Architectural Design Review Board
April 4, 2023 @ 4:00 p.m.
Council Chambers
First Floor, 345 High Street
Hamilton, Ohio 45011

To: Architectural Design Review Board
From: Dani Baxter
Subject: **Old Business - AGENDA ITEM #1**
29 S D St- Window Replacement
Brian Marischen, Applicant
Meeting Date: April 4, 2023
Received Application: February 13, 2023
Impacts: Rossville-Main Historic District

To: Architectural Design Review Board
From: Dani Baxter
Subject: **New Business - AGENDA ITEM #1**
136 N 3rd St – New storefront entry, projecting sign, vinyl privacy fence, and HVAC vent installation
Steven Gebhart, Applicant
Meeting Date: April 4, 2023
Received Application: March 13, 2023
Impacts: Central Area Building Inventory

EXISTING/DEMO WEST ELEVATION
SCALE: 3/16" = 1'-0"

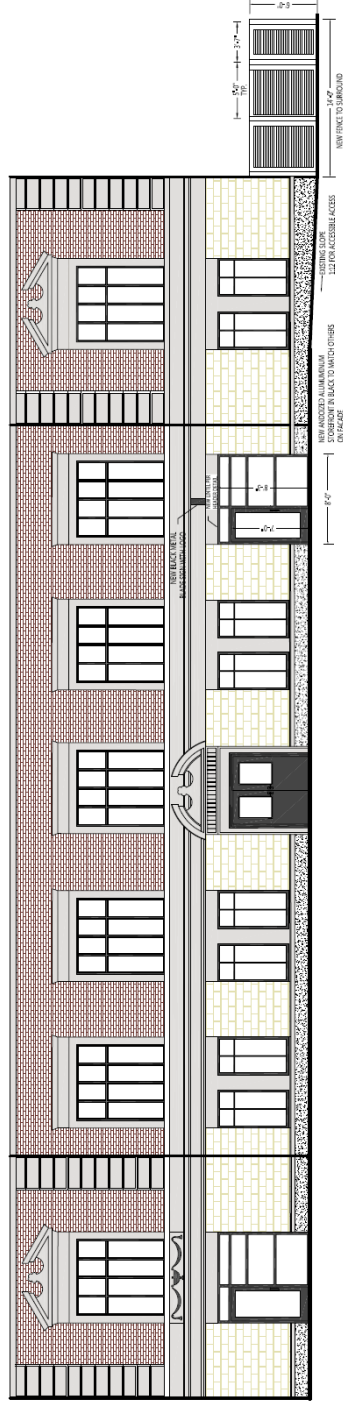
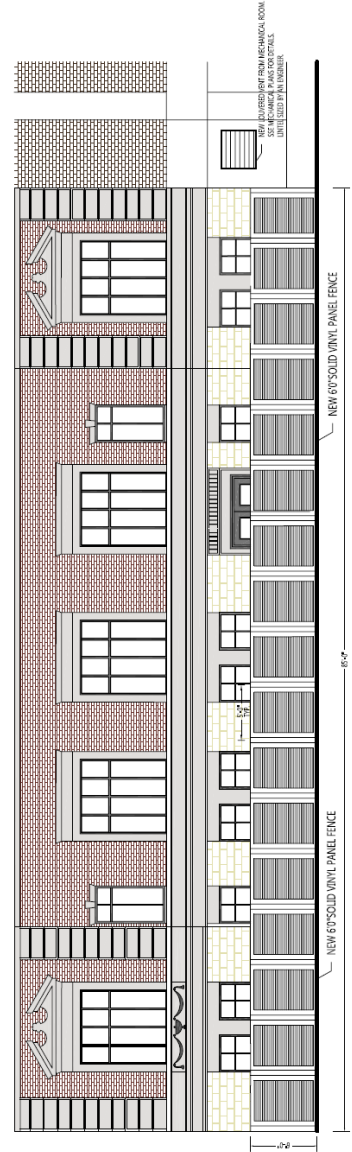
- Bark Hamilton also requires approval from Planning Commission and City Council for a Specific Use in a Business Planned Development Zone District. Bark Hamilton is set to be heard at the April 6, 2023 Planning Commission hearing.
- Magnolia Alley was vacated by Planning Commission on July 15, 2021 and ordinance number 2021-11-98.
- HVAC louvered panel vent requires a new opening in the building façade and is located between the two adjoining buildings, is setback from the alleyway, and cannot be seen from the street.
- Planning Department staff think a tan vinyl fence, matching the stone color along the first floor, would create a uniform appearance than the proposed white vinyl.
